SUNDRY NOTICES AND REPORTS ON WELLS (DO NOT USE THIS FORM FOR PROPOSALS TO DRILL OR TO DEEPEN OR PLUG BACK TO A DIFFERENT RESERVOIR. USE "APPLICATION FOR PERMIT" (FORM C-101) FOR SUCH PROPOSALS.)		WELL API NO. 30-015-47673
1. Type of Well: Oil Well ☐ Gas Well ☒ Other		5. Indicate Type of Lease STATE ☐ FEE ☒
2. Name of Operator Mewbourne Oil Company		6. State Oil & Gas Lease No.
3. Address of Operator PO Box 5270, Hobbs, NM 88240		7. Lease Name or Unit Agreement Name Layla 35 W0MD Fee
4. Well Location Unit Letter <u>N</u> : <u>225</u> feet from the <u>South</u> line and <u>1870</u> feet from the <u>West</u> line Section <u>35</u> Township <u>23S</u> Range <u>28E</u> NMPM County <u>Eddy</u>		8. Well Number <u>1H</u>
11. Elevation (Show whether DR, RKB, RT, GR, etc.) 3015' GL		9. OGRID Number <u>14744</u>
		10. Pool name or Wildcat Purple Sage Wolfcamp Gas (98220)

Mewbourne Oil Company has an approved APD for the above well. MOC requests approval to make the following changes:

Layla 35/26 W0MD Fee #1H

Layla 35/26 W0MD Fee #1H

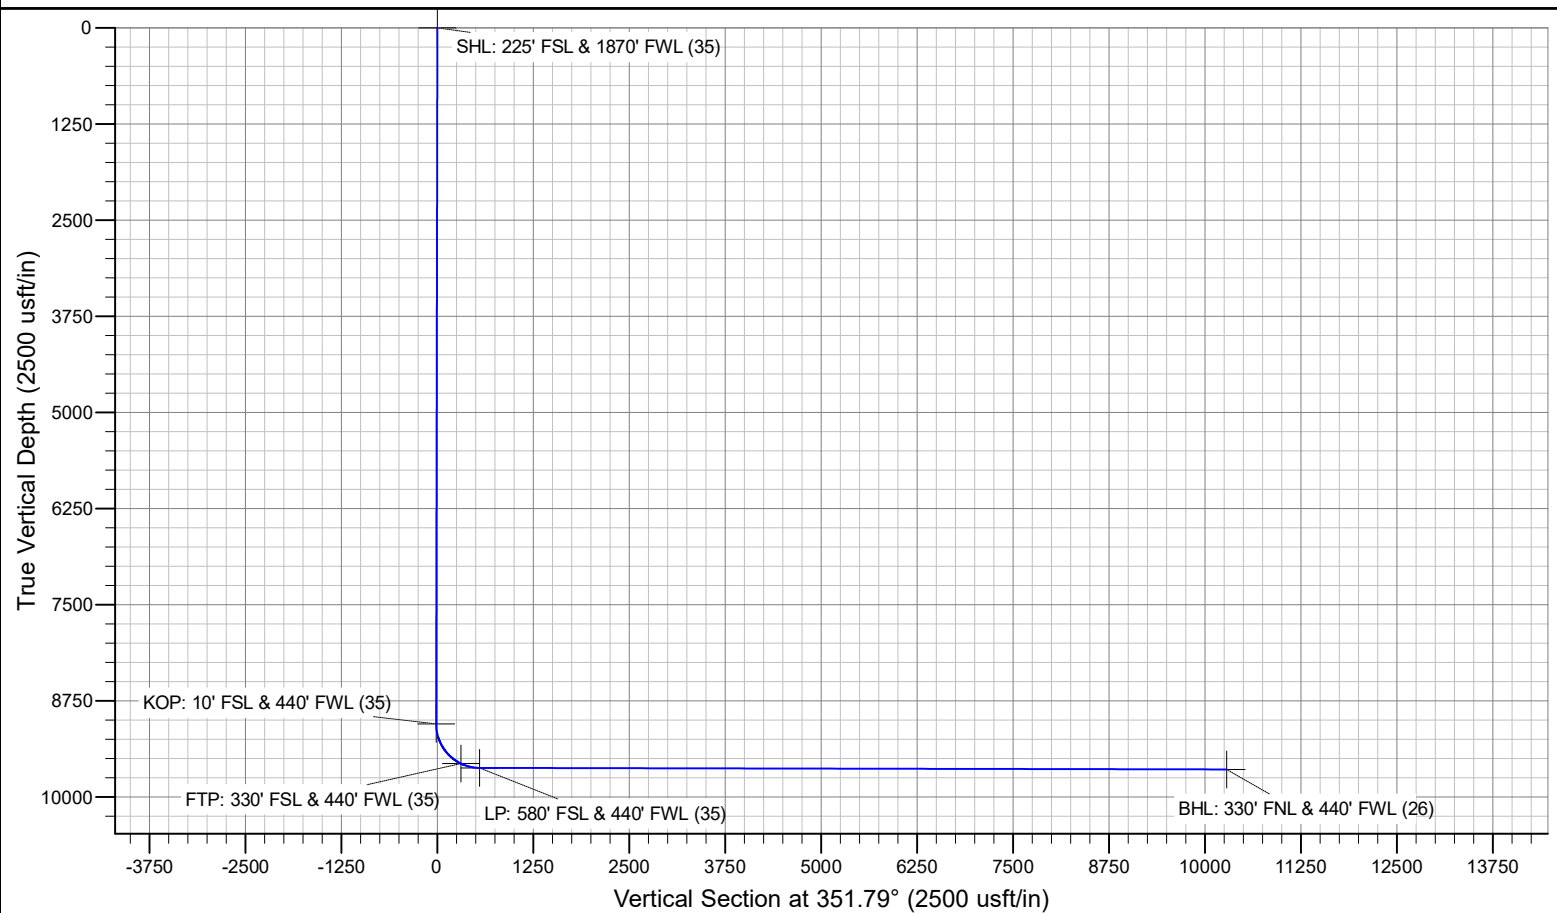
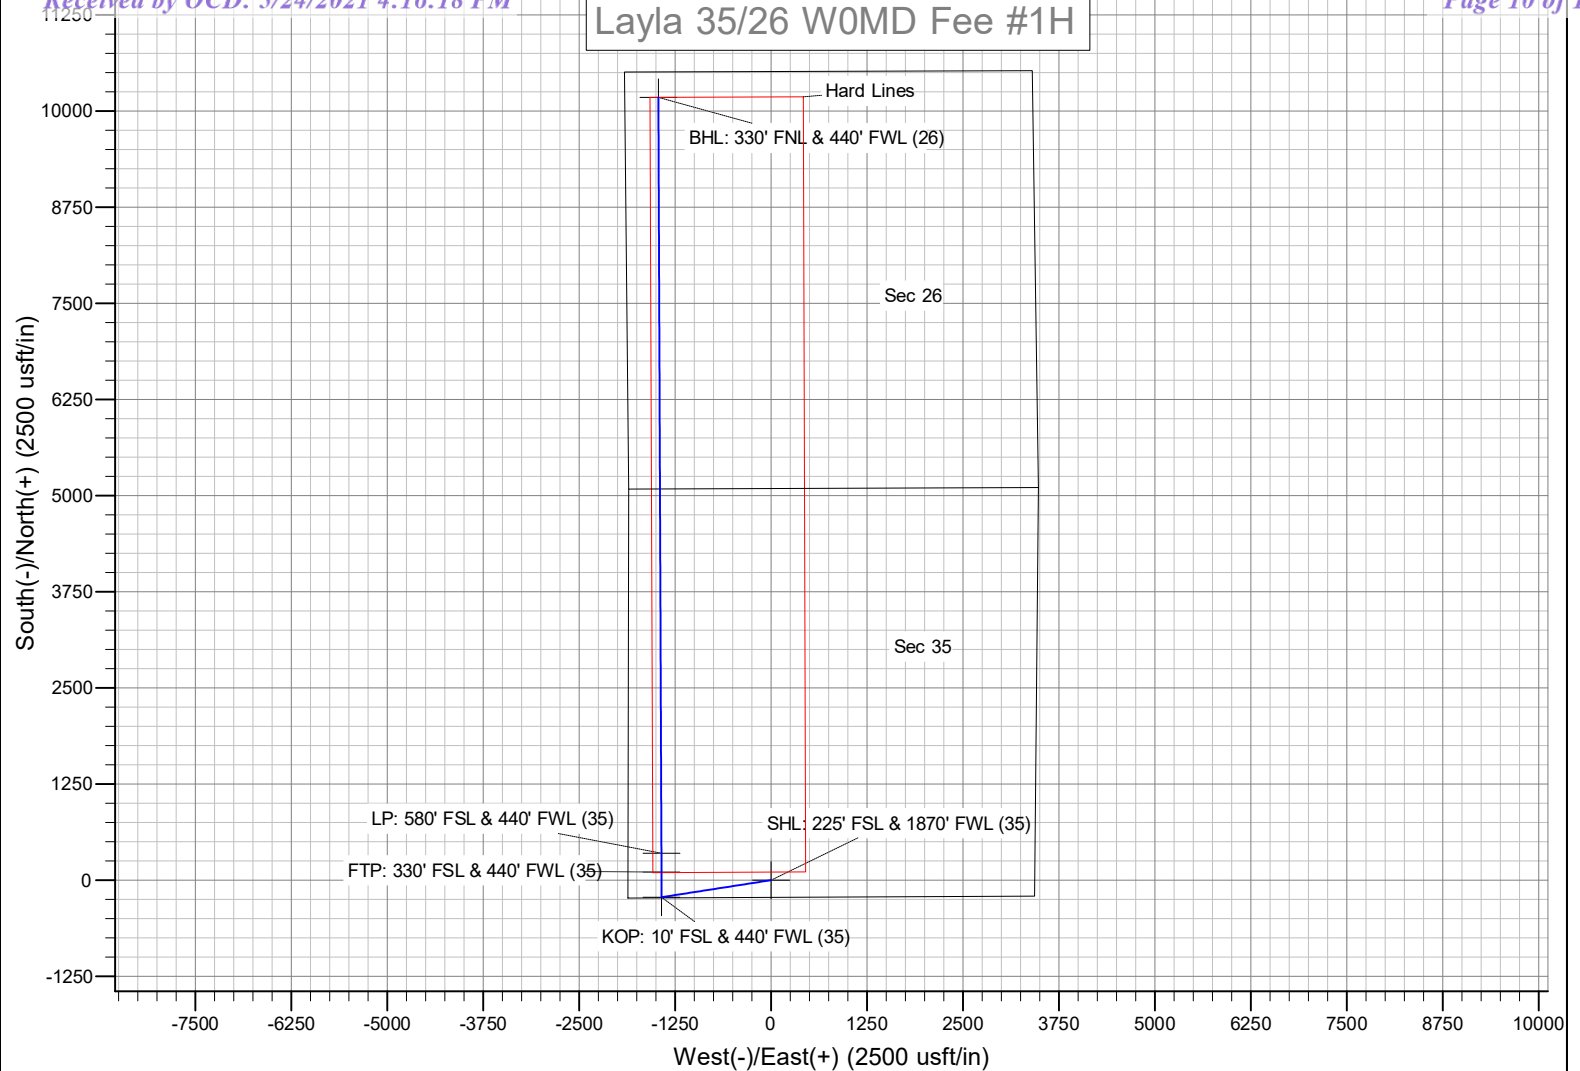
- 1) Change well name to Layla 35/26 W0MD Fee #1H.
- 2) Change BHL to 330' FNL & 440' FWL, Sec 26, T23S, R28E, Eddy County.
- 3) Change casing & cement design as detailed below
